FM 646 from FM 3436 to SH 146 PROJECT NEWS

January 12, 2023

During this public meeting, the public is invited to review materials for the proposed design changes to FM 646 from FM 3436 to SH 146, in Galveston County. Design modifications would involve extending the limits of the curb and gutter drainage system, decreasing the proposed shoulder widths, adding truck loons, shifting median openings, adding a shared use path, and minor widening of the proposed right of way (ROW) near FM 3436 and near SH 146.

Approved 2011 Roadway Design

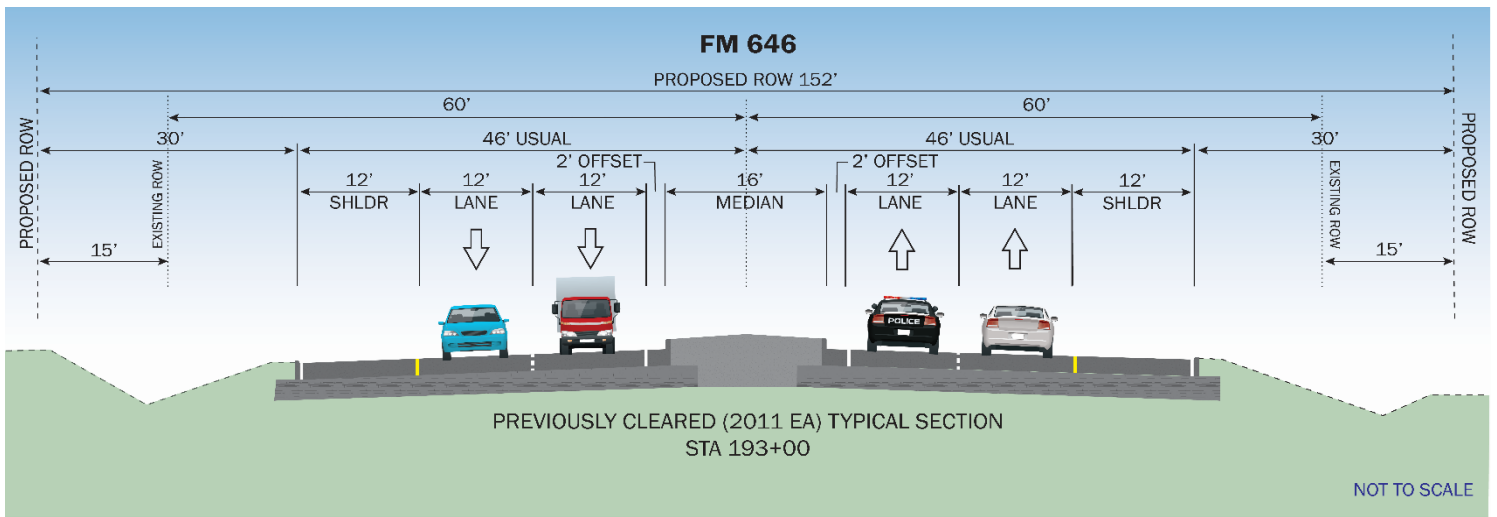
The image below represents a cross-section view of the roadway as it was approved in the 2011 design. The roadway is a four-lane, divided roadway with two 12-foot-wide travel lanes in each direction with 12-foot-wide outside shoulders. No bicycle or pedestrian accommodations were originally proposed.

The image below represents a cross-section view of how the road might look after construction of the proposed project. The following is a list of the proposed design changes in this re-evaluation:

- Addition of 12 additional feet of proposed right of way along the south side for 400 ft near FM 3436
- The extension of the limits of the curb and gutter within the project limits
- A decrease in width of the westbound shoulder from 12ft to 10ft wide
- A decrease in the width of the eastbound shoulder from 12ft to 8ft wide
- The addition of a share use path (SUP) on the south side of FM 646 for bicycles and pedestrians
- The addition of truck loons to accommodate large vehicle turning movements
- A shift in the median openings to allow better traffic flow and turning movements at major intersections
- An additional 30ft wide proposed ROW strip on the north and south sides of FM 646 near SH 146 intersection
